SAM/IG/5  
WP/12  
16/04/10

**International Civil Aviation Organization  
South American Regional Office**

**Agenda Item 3: Implementation of performance-based navigation (PBN) in the SAM Region**

**Revision proposal to ICAO documents 8168 and 9613 regarding DME limitations**

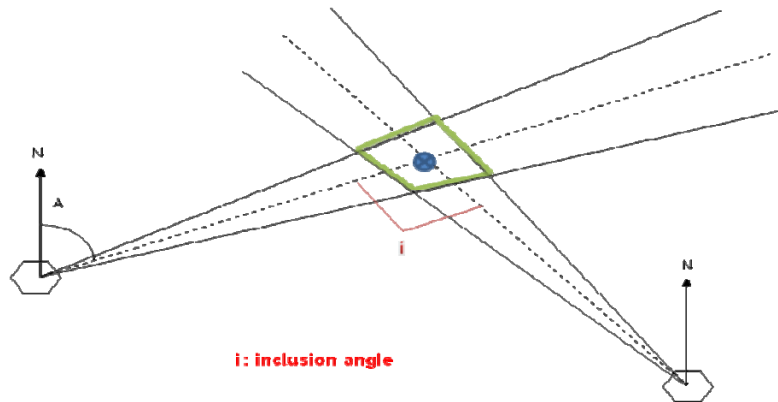
2.1 Elevation angle restriction for DME above  $40^\circ$  makes sense to diminish the error caused by the aircraft altitude, because RNAV computer (usually Flight Management System) executes the triangulation assuming the lineal distance when in fact DME calculate the slant distance. However this error could significantly increase when triangulation is executed using two DME stations with different altitude levels. For example in the Andes Mountains there are DME stations installed at sea level and DME stations 10.000 feet above sea level.

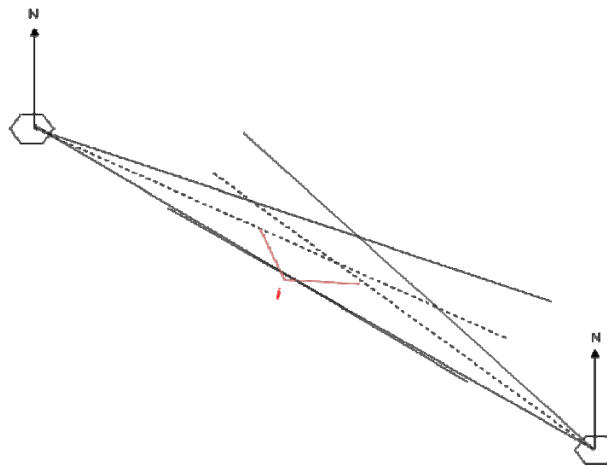
2.5 It could be mathematically demonstrated, nevertheless a graphic method has been used to explain why the inclusion angle limitation is applicable to VOR/VOR navigation, but it is not so significant to DME/DME Navigation. The next picture shows the error area around the intersection of the two VOR radials with an inclusion angle of  $90^\circ$ . The dotted lines are the measured radials and the continue lines delimitates the error (approximately  $\pm 2^\circ$ ). It is clear that error linearly increases with the distance to the station.

If the inclusion angle increases, the error area also increases and when it is near to  $180^\circ$  the position cannot be calculated as can be seen in the next picture.

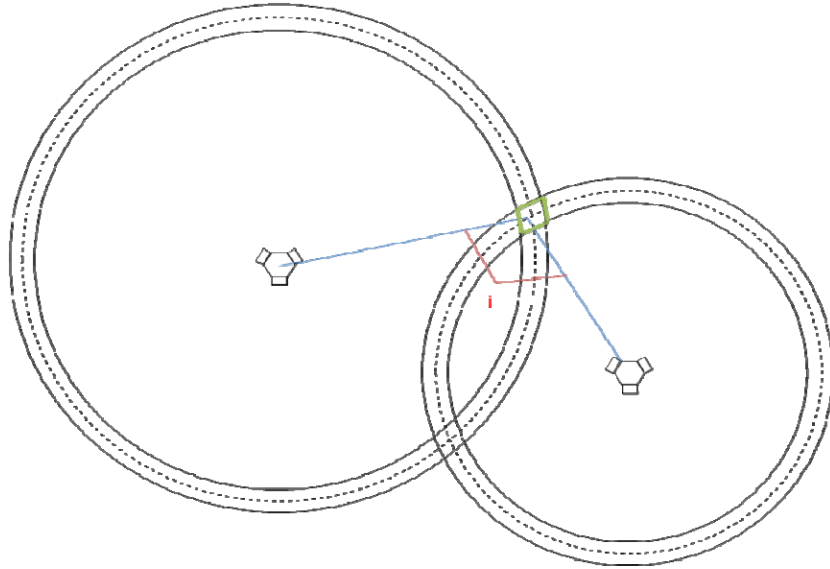
For DME the error is not angular but radial that is, the error does not depend upon the distance. This error is bordered by a circumference slightly bigger and another circumference slightly smaller. There is ambiguity because two circumferences intersect in two points. In the next picture is shown the error area around the intersection of the two circumferences with an inclusion angle near to  $100^\circ$ .

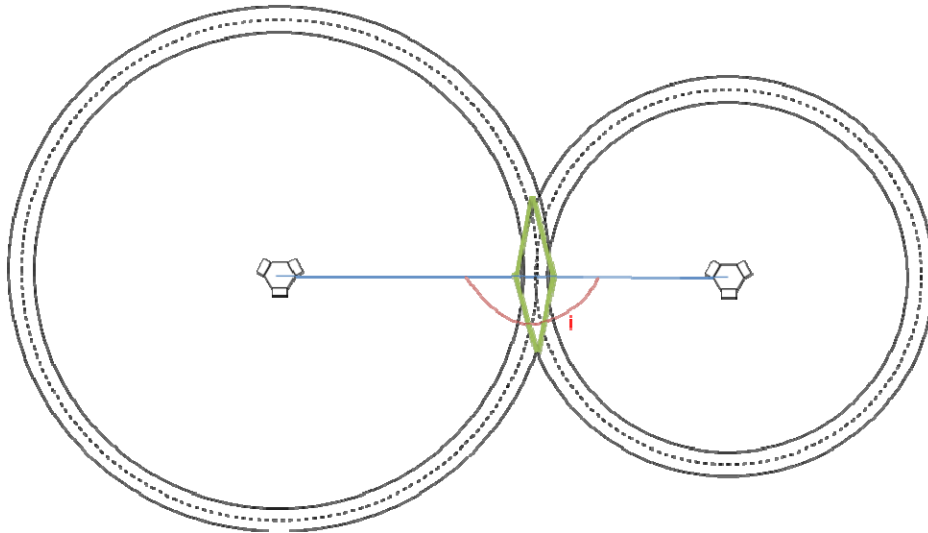
In the next picture is shown the worst case with an inclusion angle near to  $180^\circ$ , where there is no ambiguity because the circumferences are tangent and the error increases but not significantly.

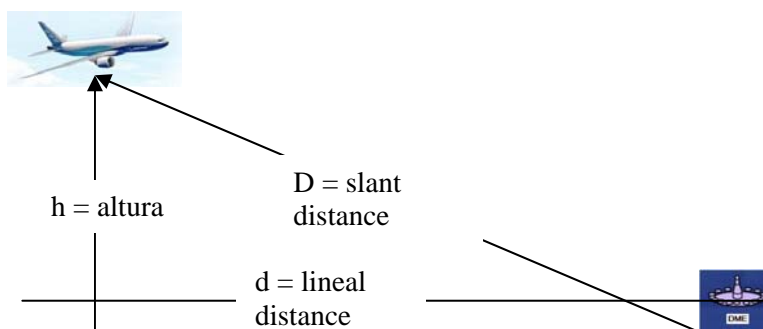
3.2 It is recommended to include aircraft altitude in the DME/DME method to reduce the error induced because the FMS computer assumes the lineal distance  $d$ , but in fact DME calculates the slant distance  $D$  (see next figure). In this way the FMS computer can easily calculate the real distance at terrain level simply by  $d = \sqrt{D^2 - h^2}$

3.3 Furthermore, the elevation angle limitation ( $40^\circ$ ) and the minimum distance limitation (3 NM) could also be suppressed because even when the aircraft is exactly on the DME station distance  $D$  is equivalent to altitude  $h$  and the FMS computer calculate  $d$  as 0.
